RE: Bendigo Ophir Project
Air Quality Assessment Review

Table 1: ORC Information Requests, PDP and SLR Responses

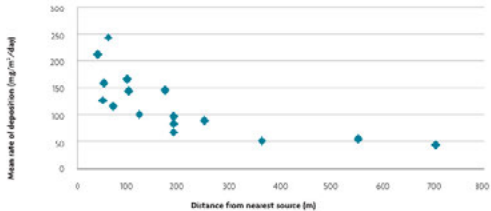
5	<p>Please provide justification for the use of 7.5 m/s wind speeds in the qualitative assessment of dust impacts, when 5.5 m/s is recommended by IAQM (2016) Method or < 5 m/s is discussed in the MfE Good Practice Guide for Assessing and Managing Dust. Your answer should include discussion on mechanically generated dust from vehicle activity (rather than from only wind-blown dust) and should also explain why PDP</p>	<p>PDP considers that the AQA adequately assesses the actual and potential adverse effects of dust, including that generated by vehicle movements. The AQA applies IAQM's Source-Pathway-Receptor framework to assess dust risks, including consideration of local meteorology and receptor distances.</p> <p>IAQM (2016) does not prescribe operational triggers; professional judgement is expected to determine site-specific wind-speed trigger levels. The 5.5 m/s wind-speed figure quoted by SLR Review is only described by the IAQM guidance as 'sometimes used as a general threshold' and states that instead of this general threshold 'it is preferable to use a wind blow initiation wind speed specific to the mineral type.'</p>	<p>The AQA stated that the GPG Dust "suggest that high-risk conditions occur when wind speeds are over 7.5 m/s". The GPG Dust never mentions this wind speed. Further in Section 7.2 the 7.5 m/s is introduced as high-risk conditions for dust generation ("dust pick up begins..."). Then in Section 7.3.4 the high wind speed travel distances are mismatched in the text stating 7.5 m/s in the second dot point (at the top of page 52) whilst presenting 10 m/s in Figure 17. Further Figure 17 compares travel distance rather than dust generation speeds).</p>

#	ORC Request	PDP Response	SLR Response
	<p>only consider high-risk winds of greater than 7.5 m/s are capable of affecting Dwelling 3.</p>	<p>Section 7.3.4 of the AQA utilises Stoke's Law of particle dynamics to estimate that wind-speeds of 5 m/s may transport dust particles (specific to the density of BOGP mine materials) up to 75 m from source, and higher wind-speeds of 7.5 m/s are required to transport these dust particles up to 150 m.</p> <p>Given that the nearest sensitive receptor to dust sources (Dwelling 3) is located approximately 140 m from the BOGP project boundary (and significantly further from construction or operational phase dust sources), only winds greater than 7.5 m/s may present a plausible transport pathway for this receptor given the site-specific density of dust particles.</p> <p>The GPG:Dust also supports site-specific triggers and limiting or ceasing dusty activities on "particularly windy days". The GPG:Dust recommends a wind-speed warning of 10 m/s (1 minute average, occurring twice in 20 minutes) as a suggested trigger level.</p> <p>Section 9.3.2 and Table 23 of the AQMP detail that a two-level trigger alert for 1-hour average wind-speeds will be implemented at BOGP as a dust mitigation measure:</p> <ul style="list-style-type: none"> • Tier 1 trigger (alert to staff for enhanced vigilance of dust): 5 m/s, 1-hour average • Tier 2 trigger (alert to staff to observe dust generating activities and mitigation measures. Cease processes if dust witnessed as crossing the BOGP boundary): 7.5 m/s, 1-hour average. 	<p>For most sources on site this does not impact the assessment, due to the significant distances between sources and receptors. For Dwelling 3, characterised as both an intermediate distance receptor (140 m, Table 33) and a close receptor (100 m, Table 38) in different sections of the AQA, the use of 7.5 m/s has potential implications for the frequency of impacts from the haul road to the entry point of Shepherds Valley (given 53.4% of winds blow in that direction).</p> <p>Rereading the AQA and the PDP response highlights that this receptor should be considered an intermediate distance receptor (140 m). Therefore, putting aside the confusion generated by the multiple designations of the receptor, the use of 7.5 m/s over other published data comes down to professional judgement. Reflecting on PDP's responses and clarification of their position around the purpose of the use of 7.5 m/s, and given the professional experience of the author and reviewers, the use of 7.5 m/s can be accepted in the context as a plausible transport pathway for an intermediate distance receptor.</p> <p>Additionally, SLR has reviewed external data (Bluett et. al. 2015¹) that supports PDP's position based on the likely distance of dust impact from haul roads to receptors. While the data reviewed was from an unfinished study the data supports limited impacts from a haul road.</p>
